The amendment revises the TSs relating to surveillance requirements of post-tensioned, prestressed concrete containment tendons.

ARKANSAS NUCLEAR ONE, UNIT NO. 1

AMENDMENT TO FACILITY OPERATING LICENSE

Amendment No. 80
License No. DPR-51

Figure 4.4.2-1

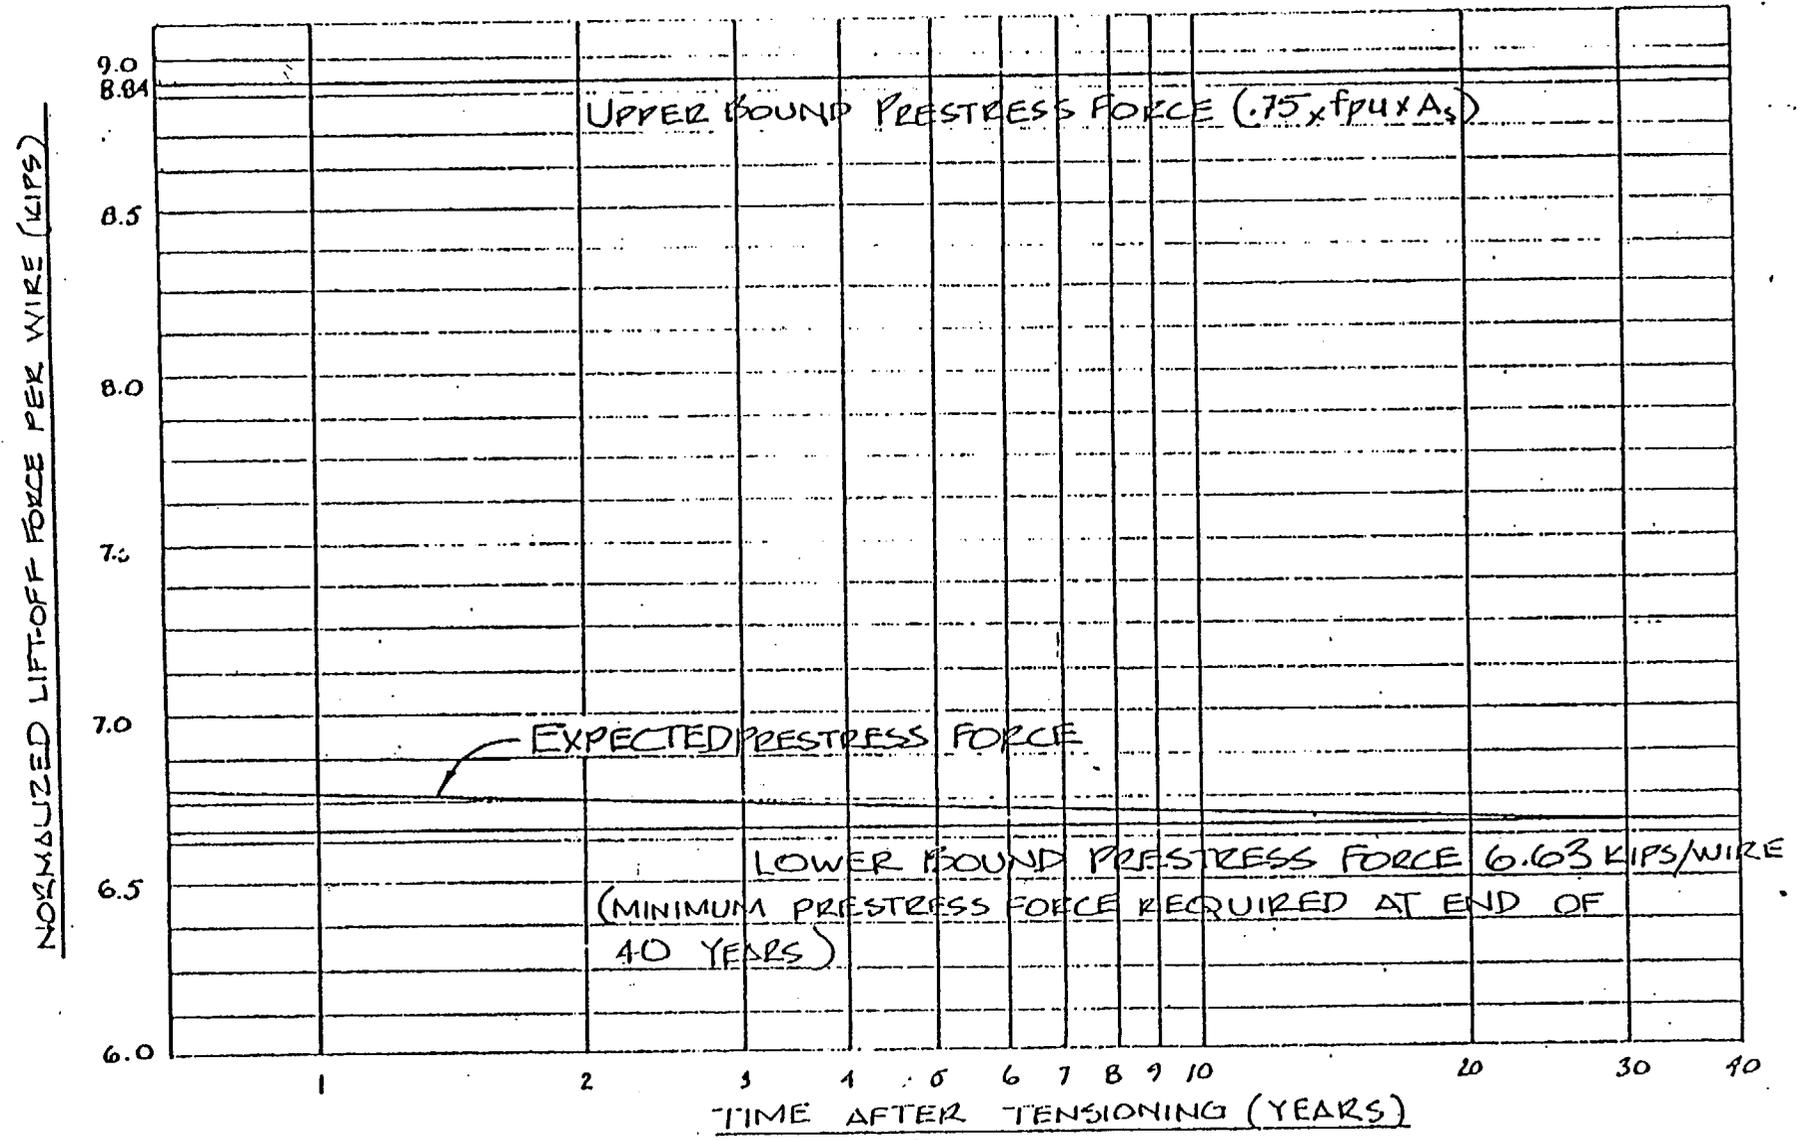
1. Each surveillance tendon has a normalized lift-off force equaling or exceeding its expected prestress force for the time of the test. See Figures 4.4.2-1, -2, and -3. If the normalized lift-off force of any one tendon in a group lies between the expected prestress force and the lower bound prestress force, an adjacent tendon on each side shall be checked for lift-off force. If both of these tendons are found acceptable, the surveillance program may proceed considering the single deficiency as unique and acceptable. If either of the adjacent tendons is found unacceptable, it shall be considered evidence of possible abnormal degradation of the containment structure. (See TS 6.12.4)
